Mercedes-Benz

Date: August 2014  
Action No.: C1A 140801  
Group: 22.00

SUBJECT: **Models 166 (ML), X166 (GL)**  
**Model Year 2015**  
**Replace Right Side Motor Mount Heat Shield**

**Figure 1**

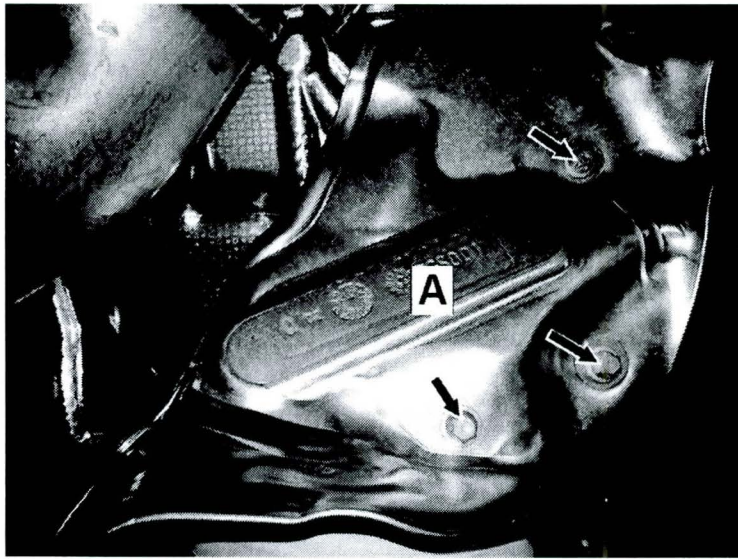
This Customer One Action has been initiated because Daimler AG (DAG) has determined that an incorrect right side motor mount heat shield was installed. Dealers are to replace the right side motor mount heat shield.

1.  Remove lower front and middle engine covers.
2.  Remove 3 bolts (arrows, Figure 1) then remove right motor mount heat shield.

4.  Install new motor mount heat shield in reverse order.

Figure 2

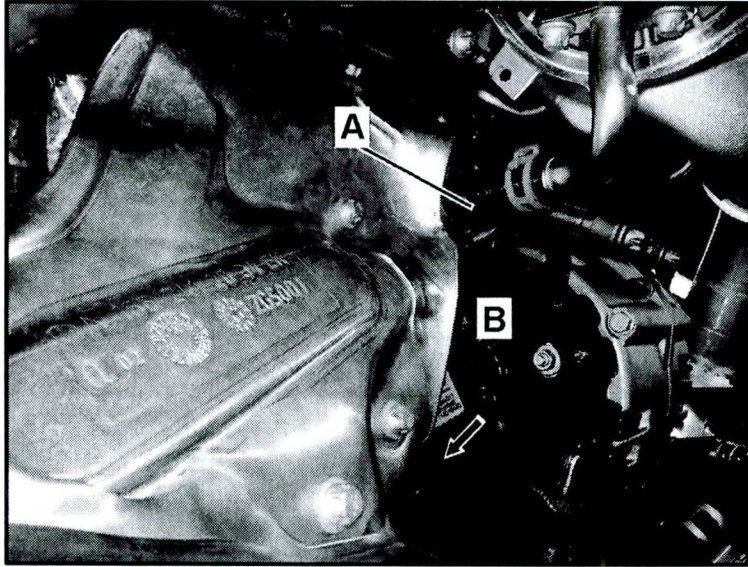
3.  Inspect turbo oil line (A, Figure 2), rear of alternator (B), engine harness to alternator (arrow) for the damage due to heat.

In the unlikely event of heat damage open a PTSS case. Include photos of the damage.
